Diggers Rest PSP

Submission for the GAA draft Precinct Structure Plans open for public comment

Figure 1: Annotated plan showing bicycle comments

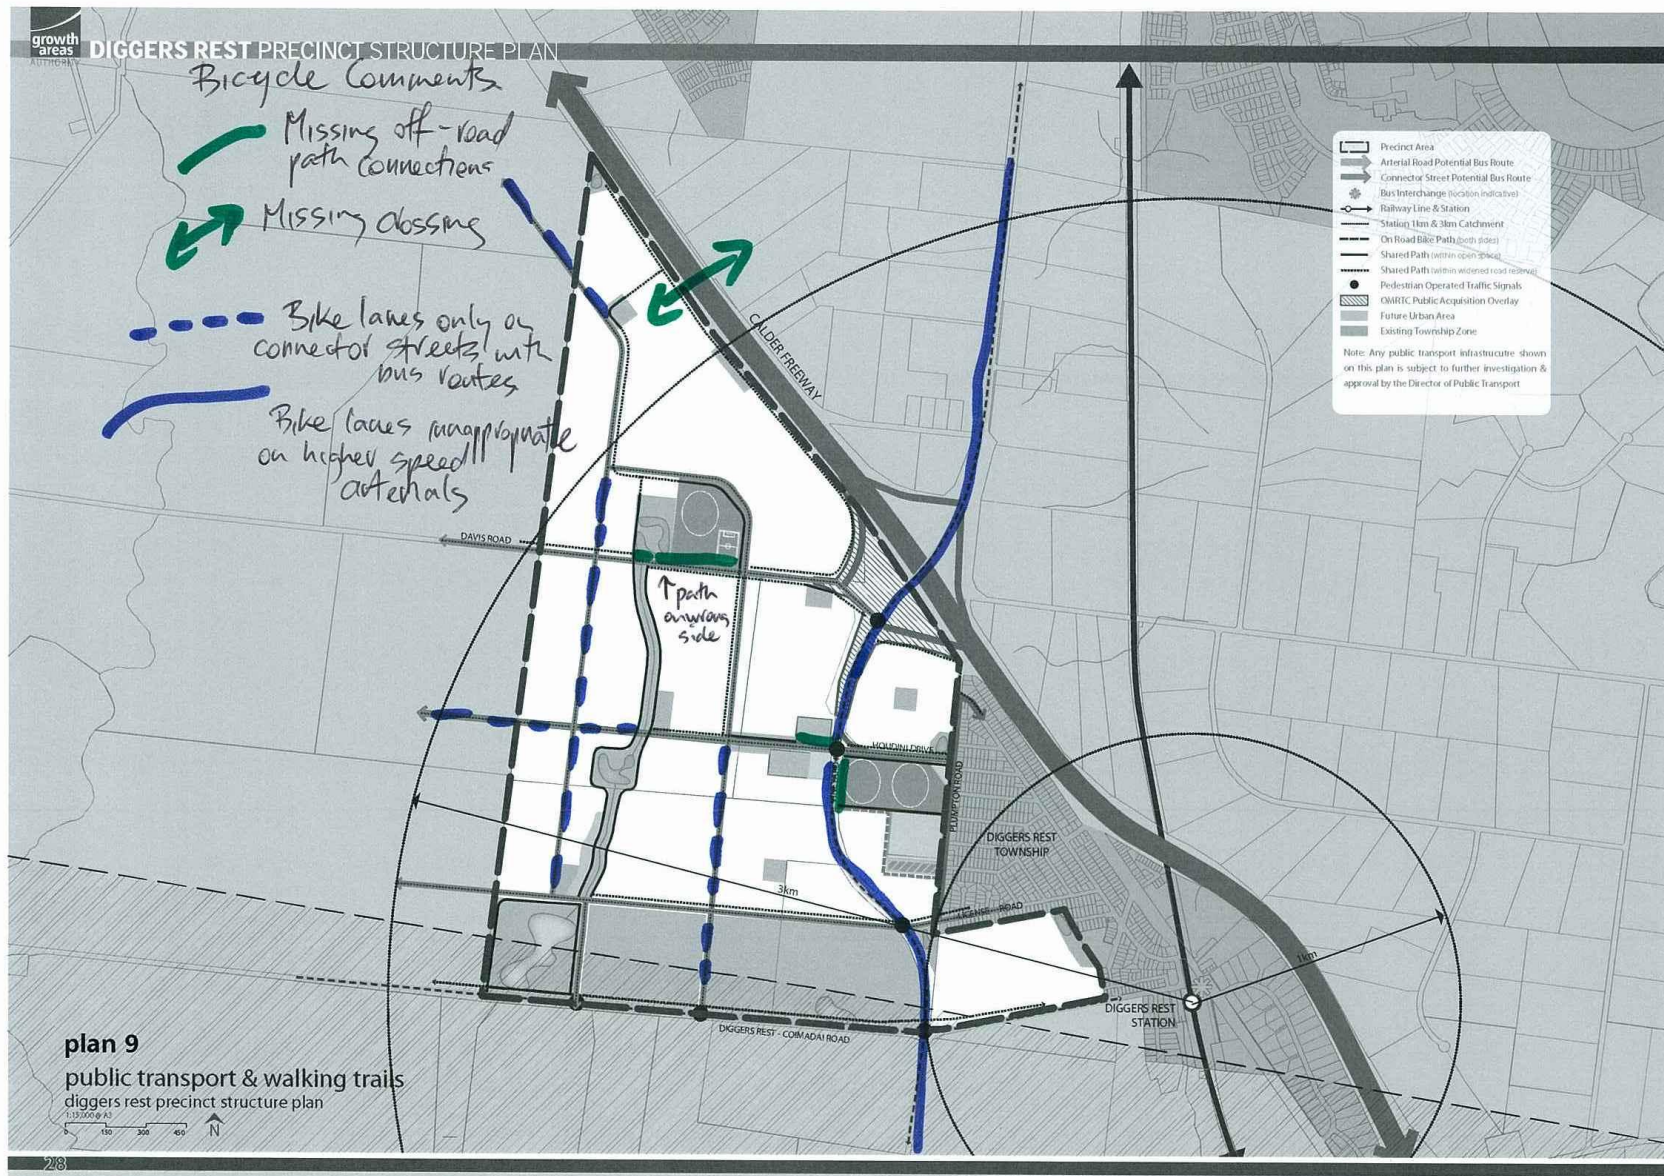
Connections to destinations - The southern Local Town Centre is isolated due to short sections of missing path along Vineyard Road and Houdini Drive.

Access into Town Centres - There is choice of bicycle routes to schools and parks but poor permeability in the Local Town Centres due to the lack of separated bike paths into the Centre. There are no marked bike lanes or paths through these centres which will have to rely on advisory bike lanes on busy connector streets carrying buses.

Crossing of barriers - The Calder Freeway to the east is a potential significant barrier for permeability to Sunbury and its destinations. A path is proposed along the western edge but there is only one crossing point indicated over 3km of length. A future crossing point is needed in the NE corner of the area where the shared path meets the Calder Fwy.

Connector streets with schools, parks, community facilities – most schools, parks and community facilities will be located on connector streets. These streets are likely to carry significant motor vehicle traffic volumes at moderate speeds (50-80km/h). On-road bike lanes on these roads are unlikely to be used by school children, family groups or novice riders and separated off-road paths, with clear and unhindered crossing of minor streets, are more appropriate. They also serve to connect to the wider off-road path network alongside parks and green corridors. The Diggers Rest plan shows off-road paths along connector street past schools, parks and community facilities. The path on Davis Road at the active open space area seems, though, to be on the wrong side of the road.

Connector streets with buses and bikes - Many of the connector streets have marked on-road bike lanes on potential bus routes. This may lead to conflict between buses and bikes as buses must cross and recross the bike lane to load and unload passengers. Off road bike paths are more appropriate on these routes as bicycles can run behind stops and high frequency bus services will not be hindered in their operation. Off-road bike paths also mean a narrower paved road width which is easier for pedestrians and potential bus passengers to cross.

Bike lanes on high speed roads – Vineyard Road in the east proposes on-road bike lanes alongside motor vehicles travelling above 70-80km/h. Austroads Guides to Road Design (2009, 2011) recommend separated bike paths for these traffic regimes and these are much more likely to be used by less confident and novice bike riders such as children and family groups who do the majority of riding in the community via short trips to school, shops and friend and for recreation. Separated, bike only paths are more appropriate for these roads but care needs to be taken to design intersections and cross overs (driveways etc.) to provide clear and unhindered passage for bike riders. A bike path that stops and gives way at minor intersections does not properly provide or encourage bike riding.

Separated bike paths from pedestrians – where high volumes of bikes riders and pedestrians are expected, especially at peak times such as before and after school, there is the potential for conflict on shared paths. This can be seen on some of the most popular existing shared paths in Melbourne such as the Main Yarra Trail and the Inner Circle Trail where high volumes of bike riders and walkers mean both are disadvantaged. This can discourage walking and cycling; especially by the more vulnerable who may be fearful of venturing onto a busy shared space. Widening of the path only works up to a certain point and then it makes more sense to provide separated bike and pedestrian paths. Experience and modelling has shown that where peak bicycle volumes exceed 200 bikes per hour with more than 100 pedestrians per hour then separate bike and pedestrian paths are appropriate. Separated bike only paths are appropriate between the State Primary School and the Local Town Centre, especially along Plumpton Rd, Vineyard Rd and Houdini Drive.
